ADDENDUM NO. TWO  
NCSB -FBMS

To the Plans and Specifications for:  
Nassau County School Board – Project No. 98110-031  
Fernandina Beach Middle School Kitchen / Dining Remodeling and Campus  
Renovations/Enhancements

Date: October 16, 2018

**LANDSCAPE AND IRRIGATION PLAN**

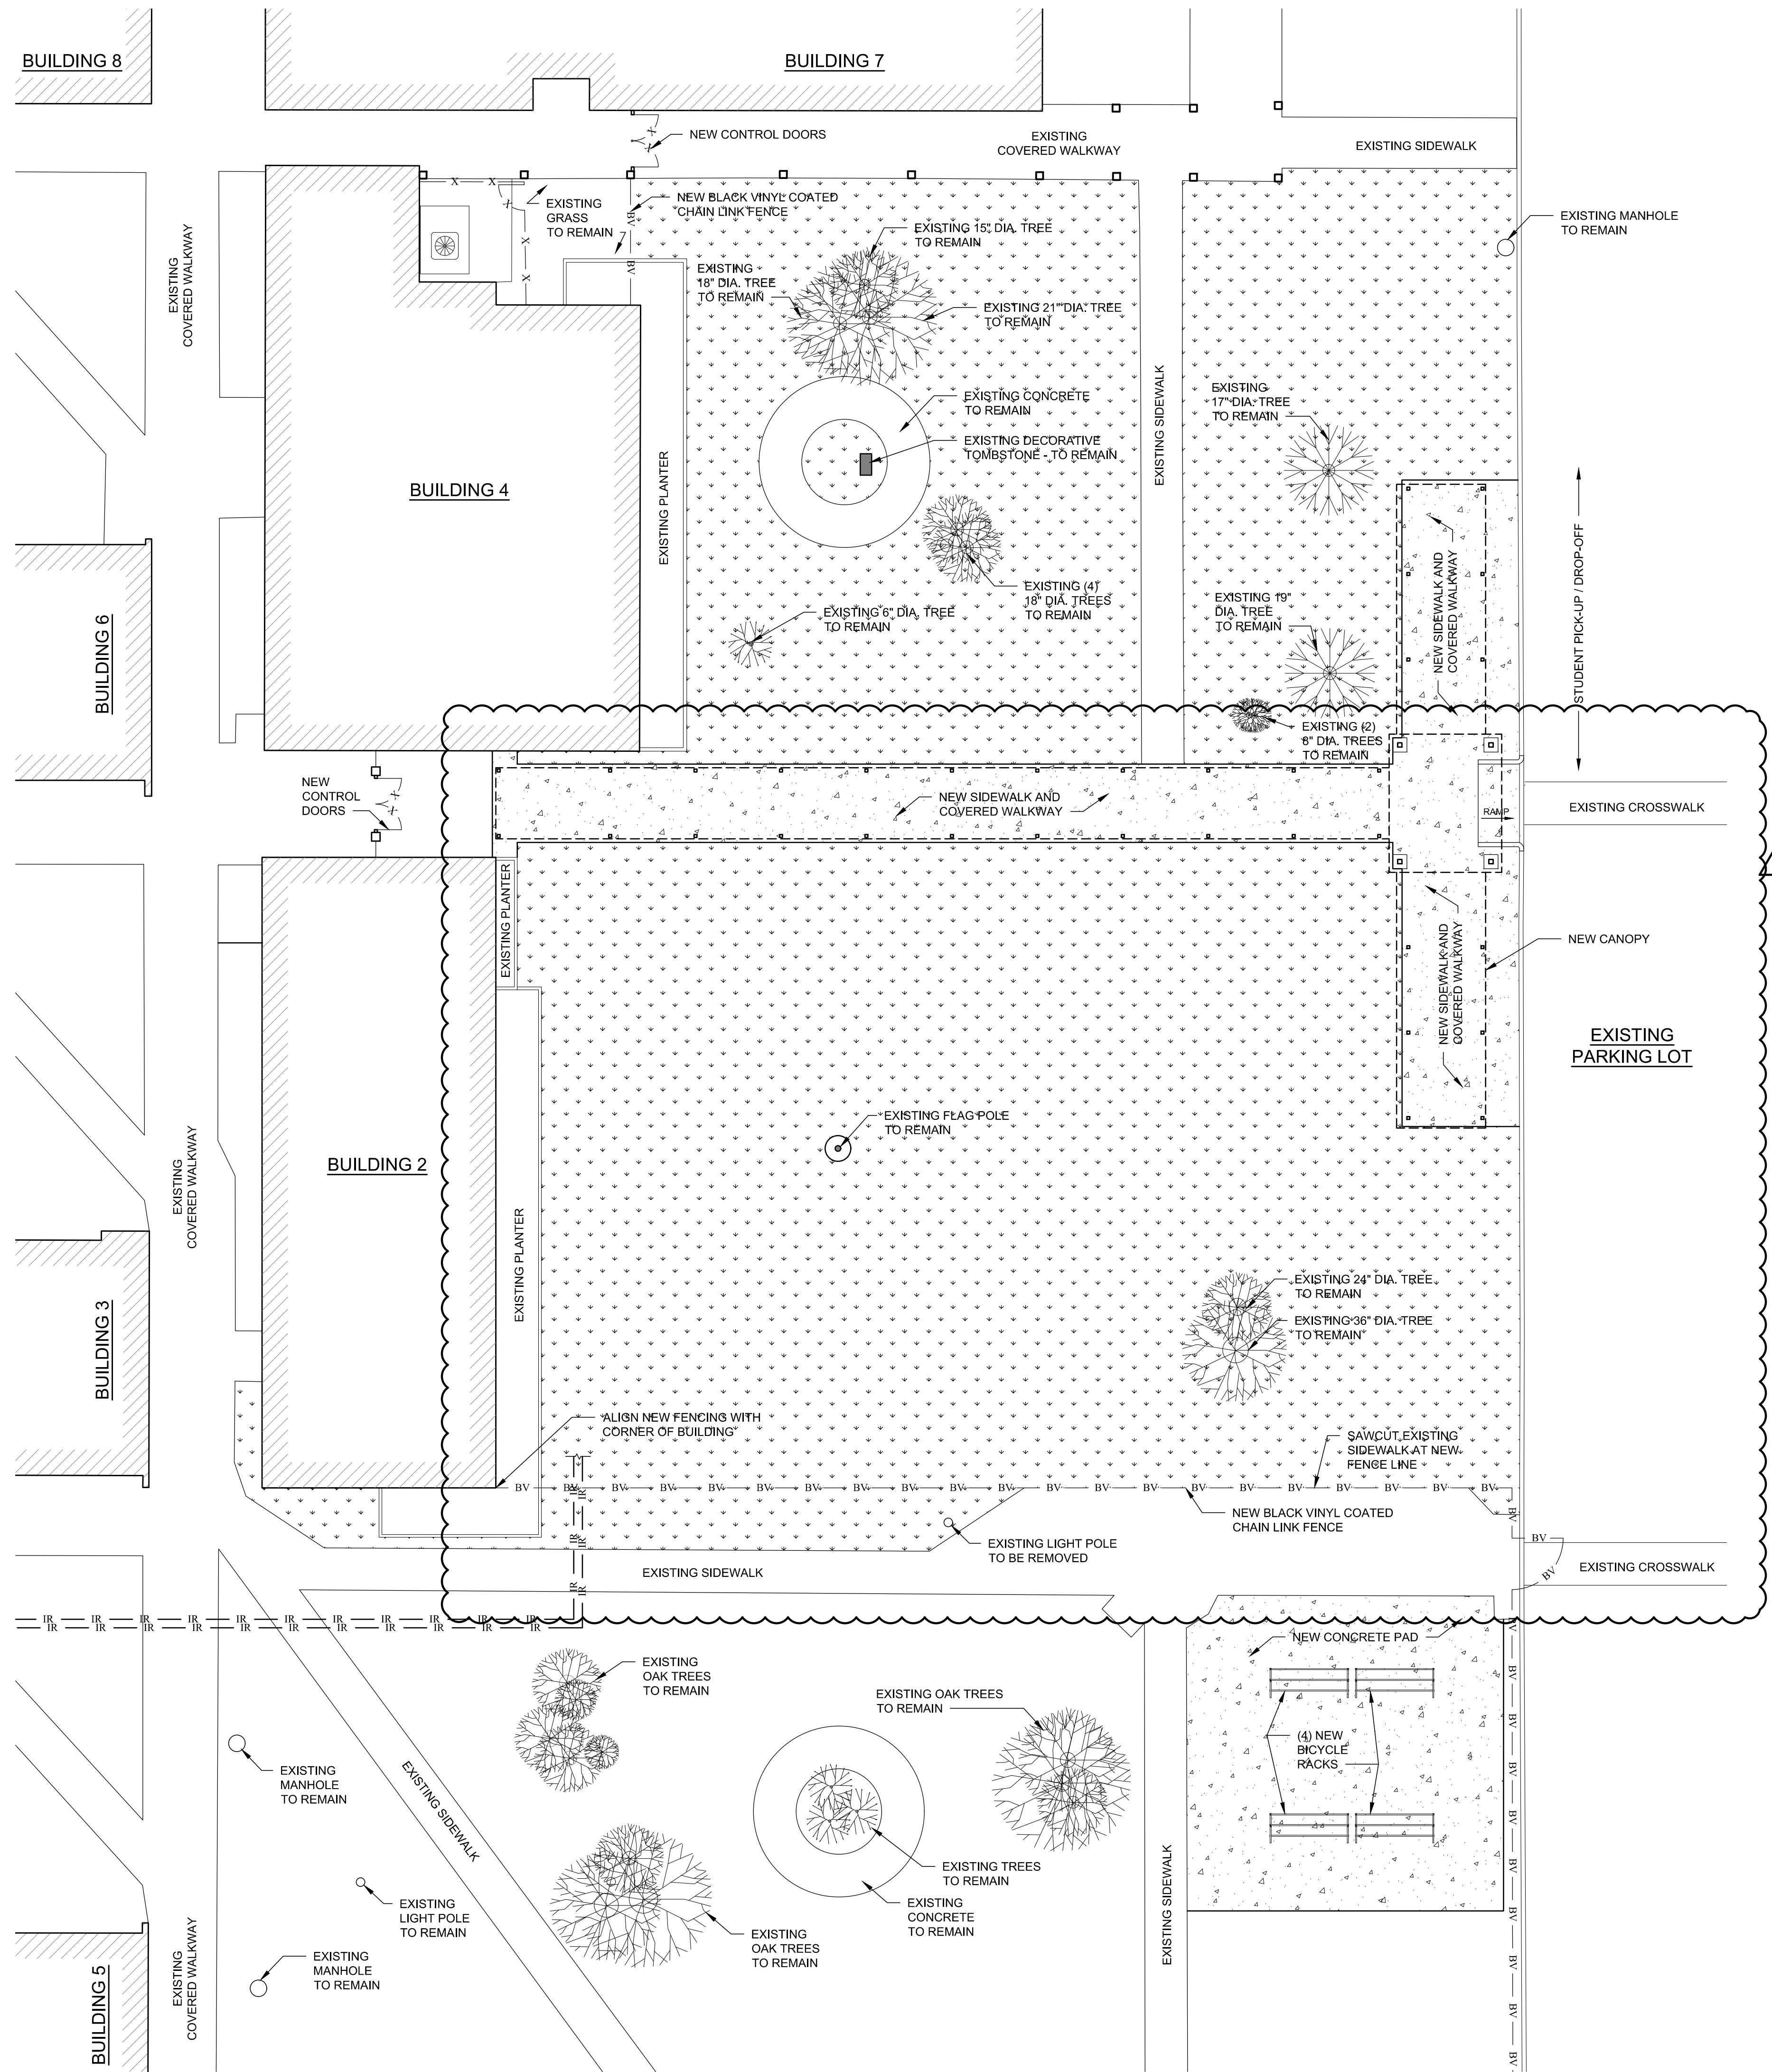
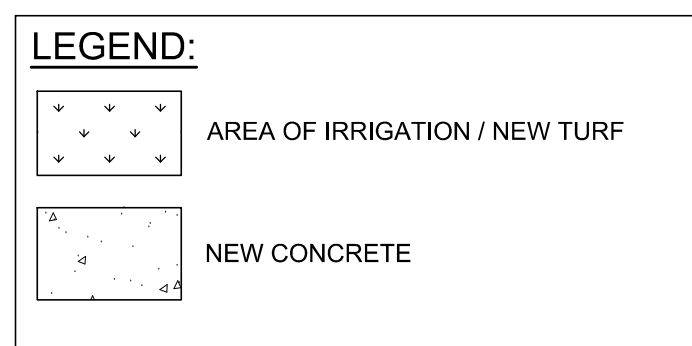
- a. Paragraph 2.4.1 – Change Item 1 to read, “Generally, sod shall be Centipede in irrigated areas. Non-irrigated areas shall be Argentine Bahia.”
- b. Paragraph 2.2 – Change references in paragraph 2.2 from “Bermuda seed” to “Argentine-Bahia seed”.

- LANDSCAPING NOTES:**
1. PROVIDE CENTIPEDE SOD IN THE IRRIGATED AREAS. SOD IN NON-IRRIGATED AREAS SHALL BE ARGENTINE BAHIA (FGBS W4.2).
  2. DO NOT LOCATE NEW TURF ON BERMS AT TREES. FGBC W4.5.
  3. PROVIDE NEW MULCH 3"-4" THICK AT PLANTING AREA BUILDING 4 AND 2 AND AT EXISTING TREES IN NEW TURF AREAS FGBC W4.7.

M-1

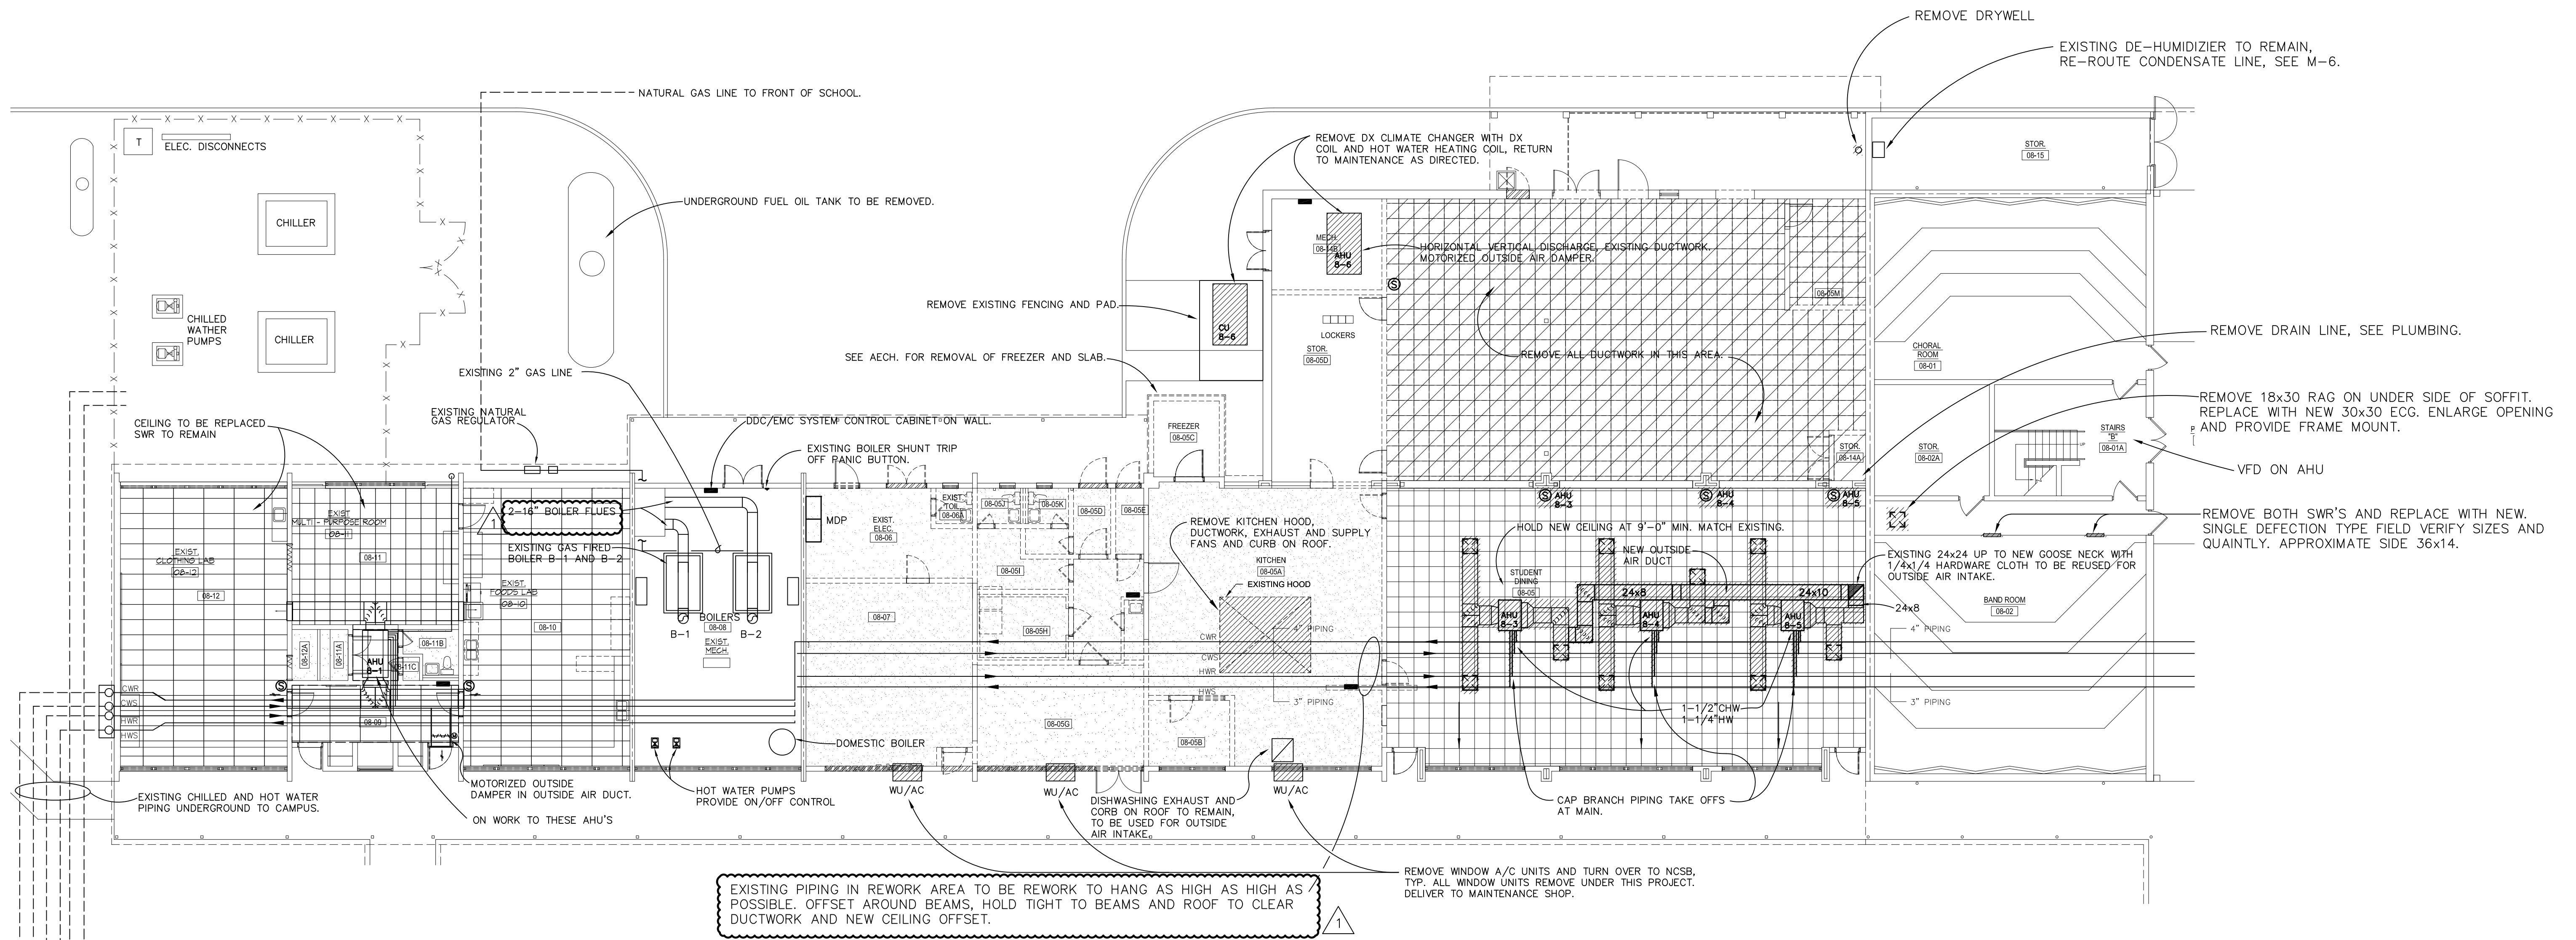
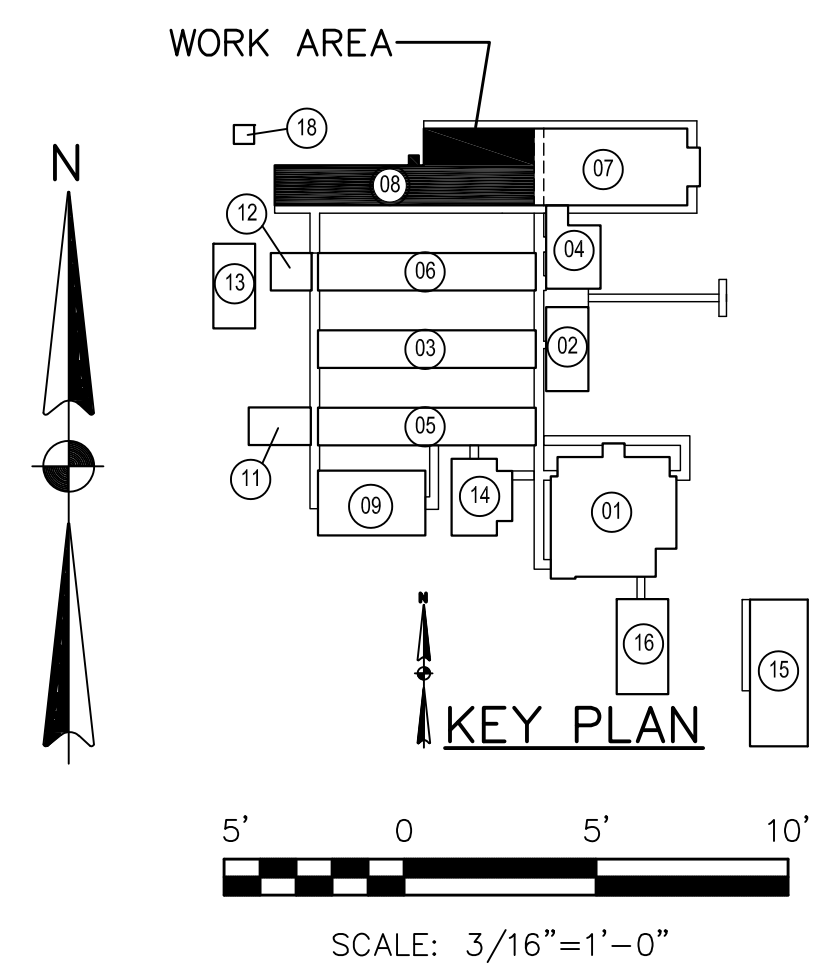
- a. Delete existing Drawing M-1, dated 9/25/2018 and insert attached Drawing M-1, dated 10/16/2018.
- b. Revise new MS2-2 in Room 02-08 to MS 2-3.
- c. Revise new MS2-3 in Room 02-09 to MS 2-4.
